**LAND SOUTH
OF
BEECH GROVE
HAYLING ISLAND**

PROPOSED ACCESS ARRANGEMENTS

Stage 1 Road Safety Audit

SEPTEMBER 2012

DATE	SEPT '12	DRAWN	JGP	CHECKED	DLW	ISSUE CHECKBOX
DRAWING No.	3726.001	REV.	A	SCALE	1:500	© A4

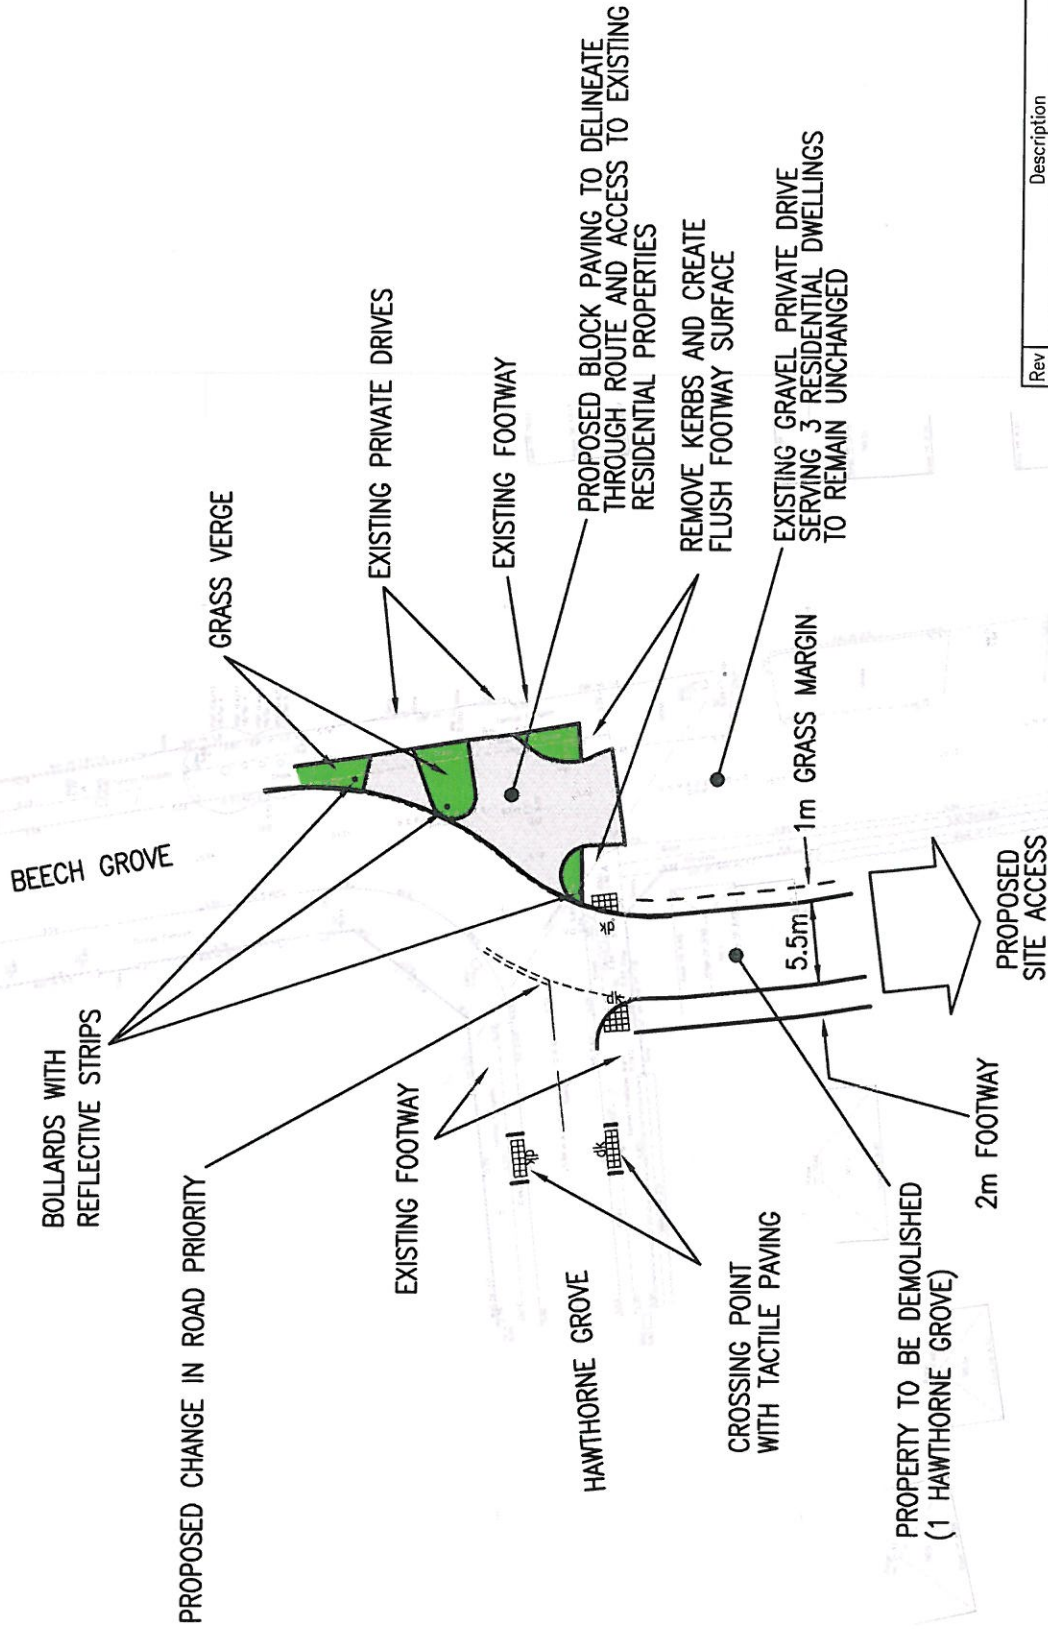
The proposed realignment of Beech Grove to accommodate the new access road may create a "see through" problem for motorists travelling south on Beech Grove. This may result in motorists approaching the development access road at inappropriate speeds which could lead to late braking or loss of control conflicts.

Provide bollards with reflective strips on the verges to highlight to drivers the realigned carriageway. Provide edge of carriageway and access markings to further enhance the realignment.

There are no indications that tactile paving will be provided at the new access. The absence of tactile paving and dropped kerbs may increase the risk of pedestrians with visual impairments falling/tripping on full height kerbs or failing to stop at crossing points and walking out in front of oncoming traffic.

The design is amended to provide tactile paving and dropped kerbs across Hawthorne Grove.

Problem no. in safety audit report	Problem accepted (yes/no)	Recommended measure accepted (yes/no)	Alternative measure (detail description)
3.1	Yes	Yes	N/A
3.2	Yes	Yes	N/A

Rev	Description	Drn	Chk	Date
A	UPDATED TO REFLECT TOPO SURVEY & RSA1	ADW	DLW	SEP 12
